**Re: DOCKET NO. 503 – Arx Wireless Infrastructure, LLC application for a Certificate of Environmental Compatibility and Public Need for the construction, maintenance and operation of a telecommunications facility located at 43 Osgood Avenue, New Britain, Connecticut**

**New Cingular Wireless PCS LLC's (AT&T) Response to Interrogatories**

**RESPONSES OF INTERVENOR NEW CINGULAR WIRELESS PCS, LLC  
d/b/a AT&T TO CONNECTICUT SITING COUNCIL PRE-HEARING  
INTERROGATORIES**

# **Attachment A**

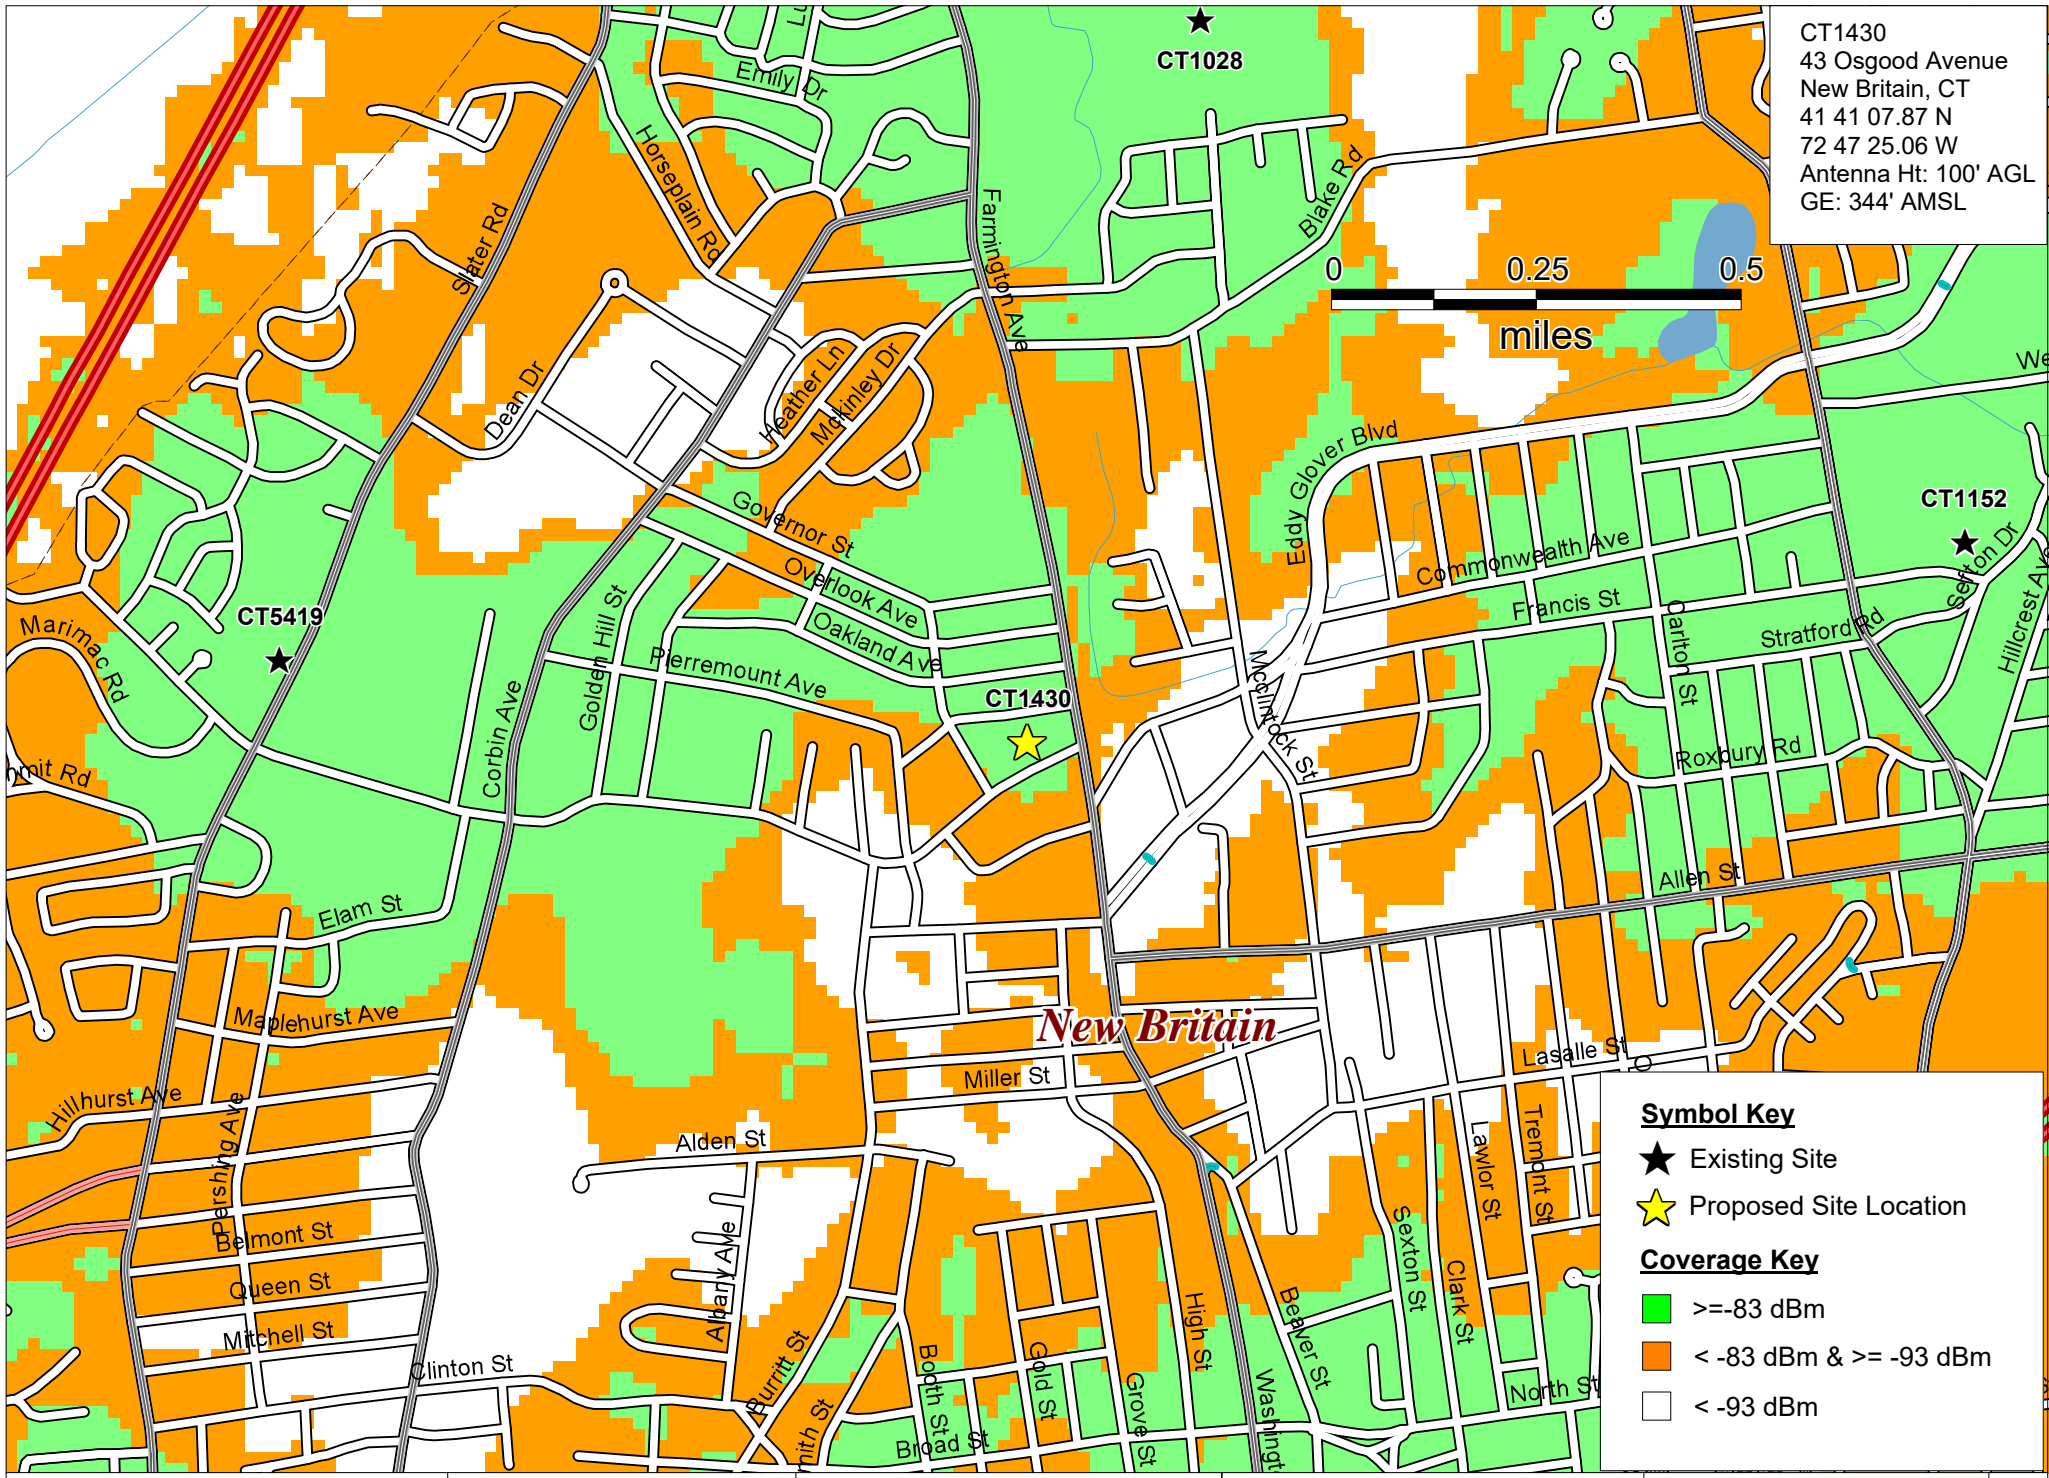
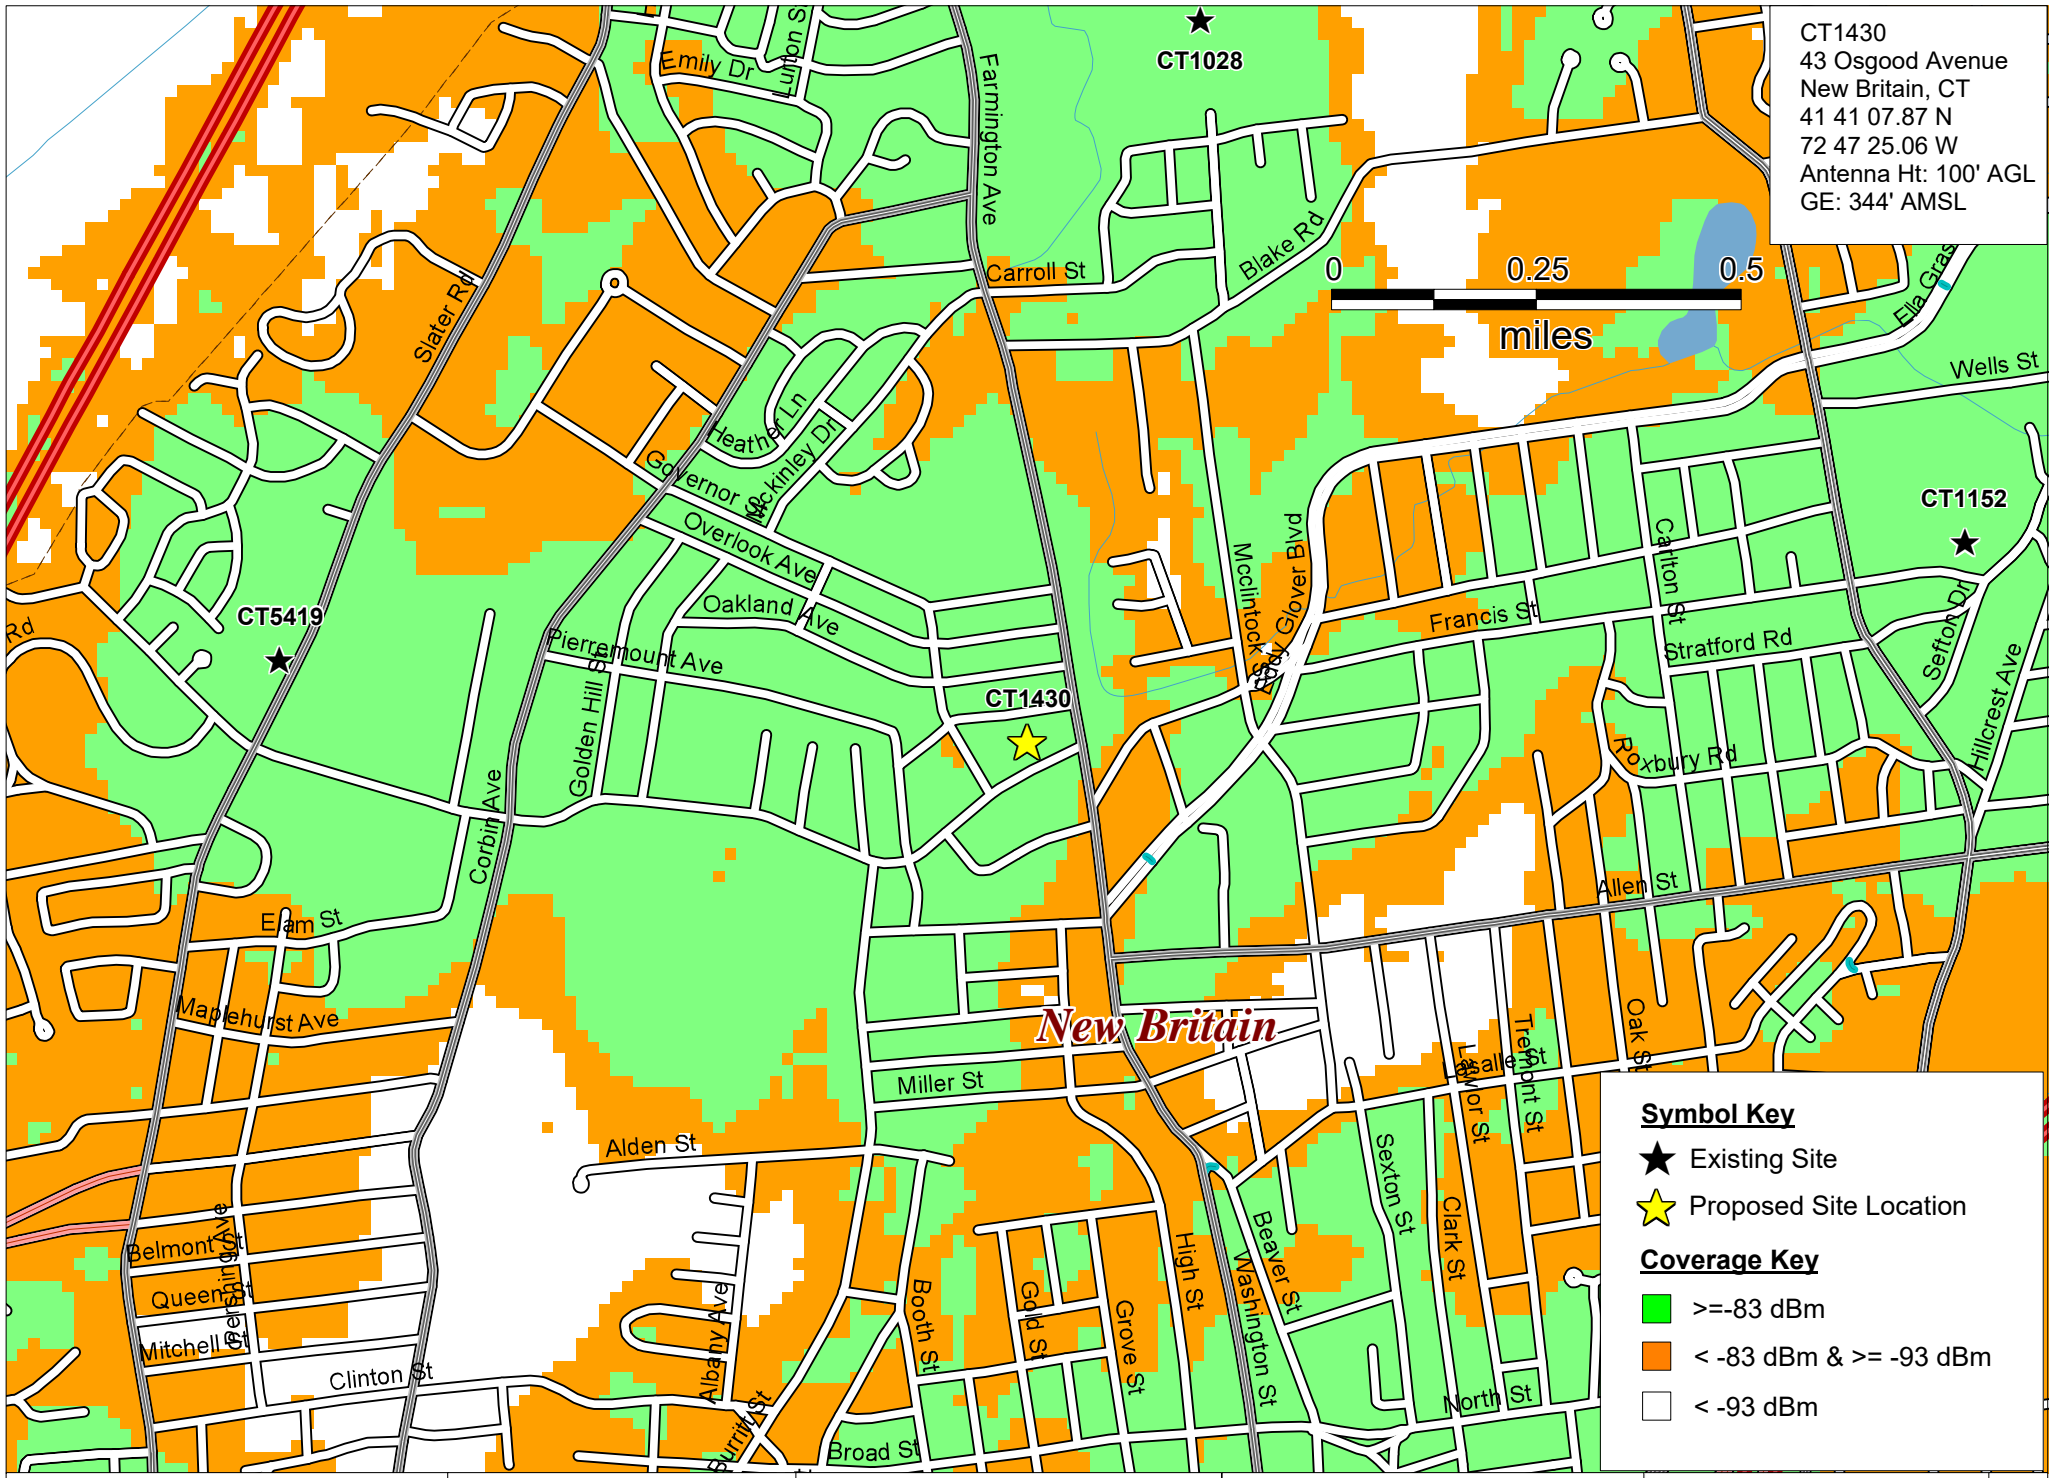
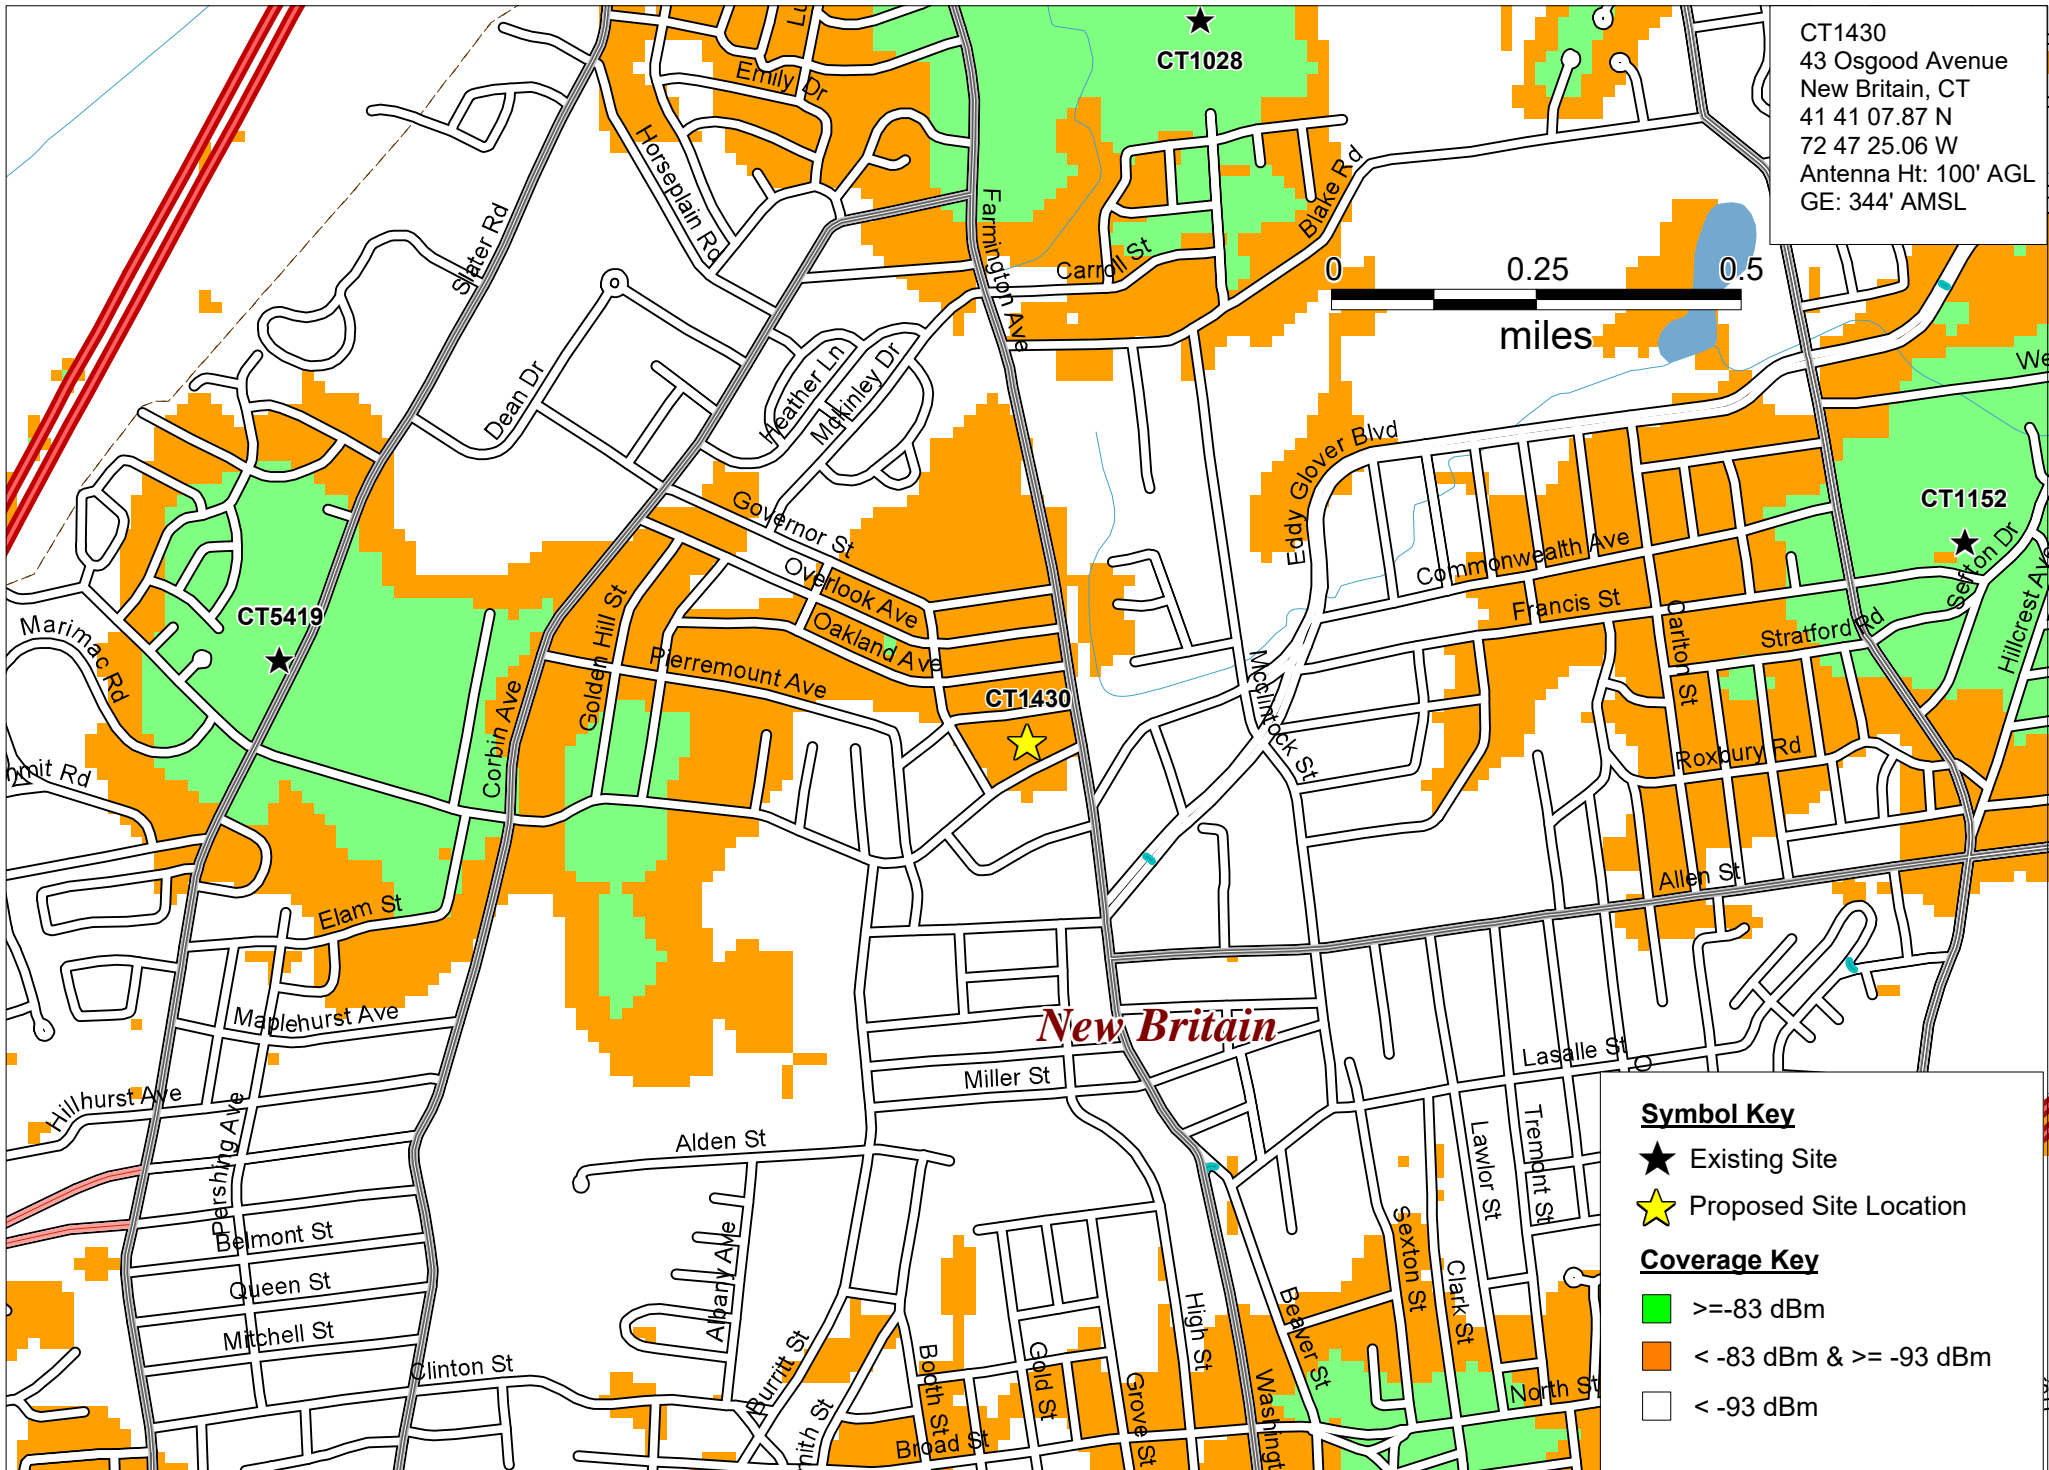
Q8. Provide existing coverage plots for each frequency band to be deployed by AT&T at the site. Provide a similar set of plots for each frequency band that include existing plus proposed coverage.

A8. *Please see the coverage plot included in Attachment A.*
